# TECHNICAL BULLETIN

[Issue No.] T99-0045

[Title] Precaution when replacing the discontinued CC-Link compact type remote I/O module (AJ65SBTB2-□□□)  
with the alternative (AJ65SBTB2N-□□□)

Fig. 1 Replacing the discontinued model (AJ65SBTB2-□□□) with the alternative (AJ65SBTB2N-□□□)

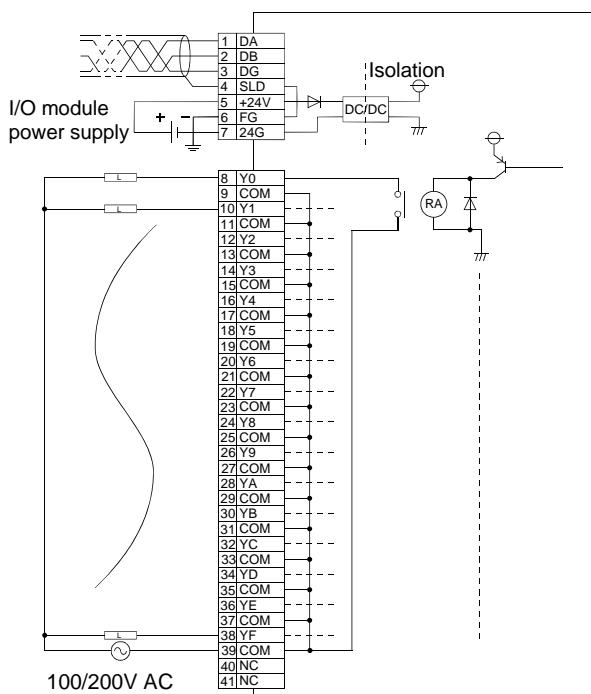
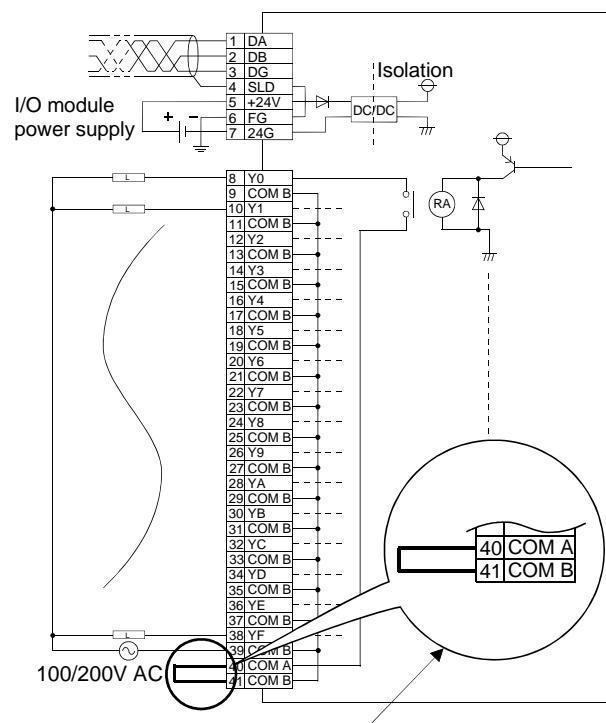
Common terminal wiring is different between the discontinued and alternative models.

Connect an external cable between terminals COM A and COM B as shown in Fig.1 to replace the discontinued model with the corresponding alternative.

Connection between terminals COM A and COM B
